To affected users of Siemens Healthineers
MAGNETOM
 Free.Max/Free.Star/Amira/Sempra/Mica/Spectra

Customer Safety Advisory Notice MR078/23/S

Customer Information about possible artifacts from over-ear headphones during head examinations

Figure 1: Location of model number and serial number on over-ear headphones

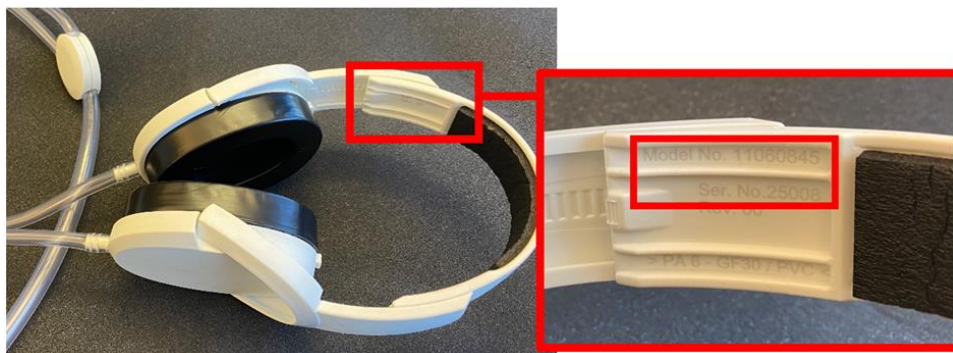
- Check the model number and serial number of your over-ear headphones. See *Figure 1* for their location on the over-ear headphones. If the model number is not identical or the serial number is outside the stated range (7981 – 32200), they are not affected.

Figure 2

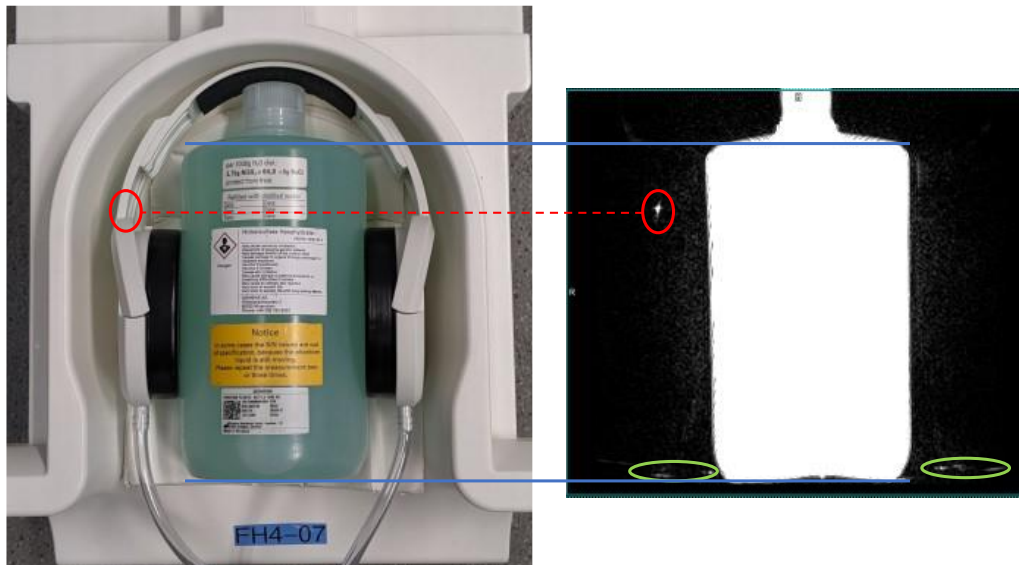
Left side: correct setup of phantom bottle and headphones in head coil

Right side: Example of signal from lubricating grease can be seen outside the phantom, marked with a red circle. The artifacts must be on the same height as the potential affected headbands of the headphone.

Please note: MR imaging often shows artifacts with phantom bottles in this extreme windowing e.g. at the top and/or bottom of the phantom. These artifacts are marked with green circles in the above example and can be ignored.

- Set up with phantom bottle and headphones as shown in *Figure 2* below.
 - Use the standard sequence t1_fl3d_sag_p2_iso (from Siemens protocol tree: head -> library -> 3D) with the minimum possible echo time TE, repetition time TR of 10 ms, field of view (FOV) of 250 mm and coronal orientation.

- Apply window values of approx. C=20 and W=10 to identify if artifacts from lubricating grease clumps are present outside of the skull at the position of the headband of the headphones.

- **If no artifacts are visible** during the described phantom measurements, your over-ear headphones are not affected and can continue to be used for MRI head examinations.

- **If artifacts are visible** during the described phantom measurements, your over-ear headphones are affected and must not be used for head examinations. In this case, please use the built-in loudspeaker in the scanner for patient communication or, if available, in-ear headphones which are also not affected by the described issue.
